**ATTENTION: ELECTRICAL CONTRACTORS, SUPPLIERS AND  
DISTRICT ENGINEERING, CONSTRUCTION & OPERATIONS  
PERSONNEL**

**SUBJECT: Electrical Service Manual (ESR)**

Several revisions have been made to the ESR since the last publication. Please find enclosed the revised documentation to be inserted in your manual. Current revisions are shown in red with a black vertical bar on the left border. A brief description of the revisions are as follows:

**FIGURE 4-21**

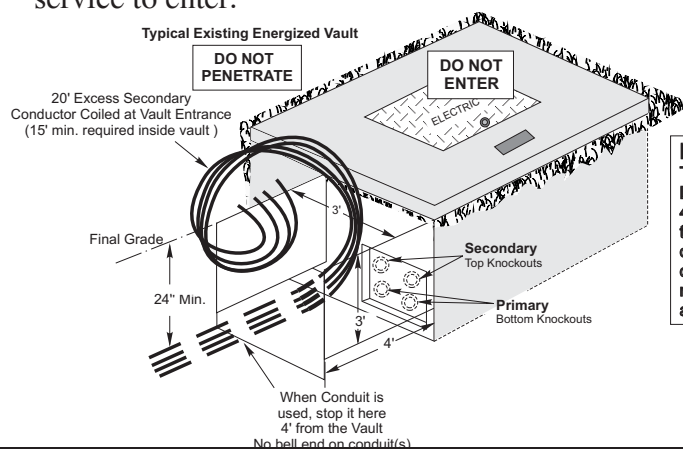
Page 4-42 specifies 20' of excess conductor required to comply with Figure 4-21.

1. When adding secondary feeds to an existing energized padmount transformer, secondary handhole or pedestal, stop outside the vault and provide **20' of excess conductor and** a work hole 3 foot wide x 3 foot deep x 4 foot back from vault for **District personnel to penetrate the vault, extend the conductors and/or conduit(s) and make the connections.**
2. Any costs associated with damage and repair to the existing primary, secondary(s) or ground wires are the responsibility of the customer/contractor.
3. **Under no circumstance shall the Customer penetrate the wall of an existing energized vault with either conduit or conductor. Only District personnel are authorized to penetrate into an existing energized vault.**
4. Contact engineering to determine which corner of an existing vault is available for the service to enter.

#### **Typical net metered solar installation 1Ø 25 kW or Less**

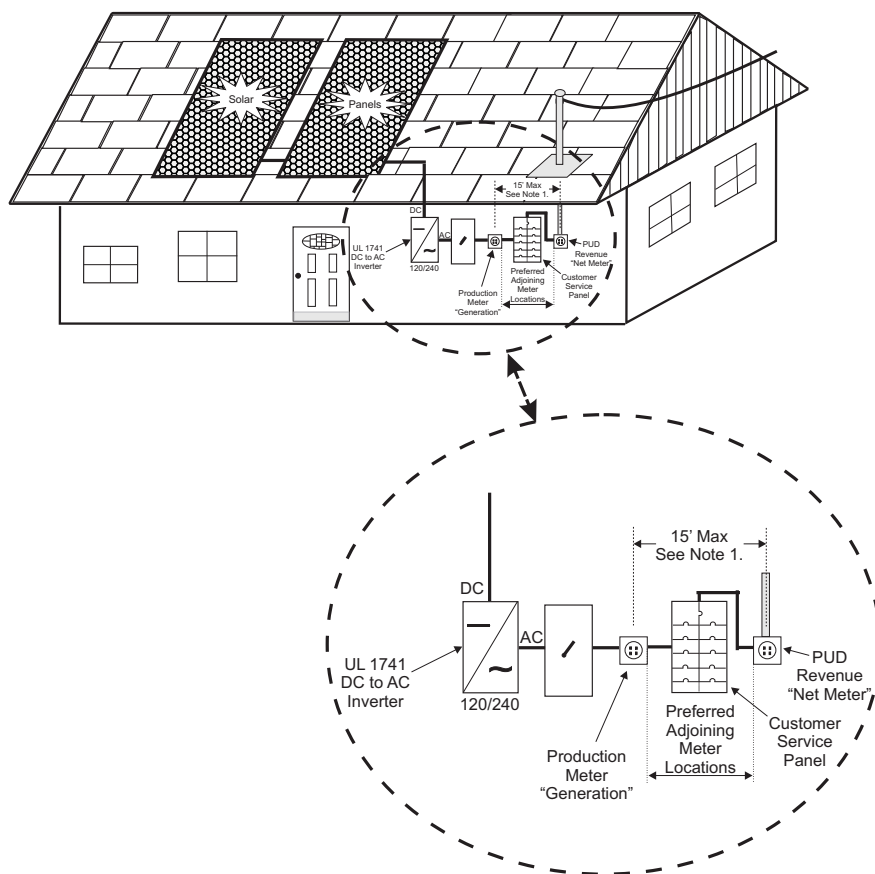
Pages 6-16 revised to provide more detailed information regarding the visible-open lockable disconnect switch requirement.

1. Preferred location for District revenue meter is within 15' of production meter. Greater distances may be acceptable with prior District approval before installation.
2. Production meter is for the Washington State Renewable Energy Production Incentive.
3. A visible-open lockable disconnect switch is required for all systems 25kW and greater. This switch must be accessible at all times to District personnel.  
Single-phase 120/240 volt systems under 25kW metered with a self-contained meter do not require a visible disconnect switch.
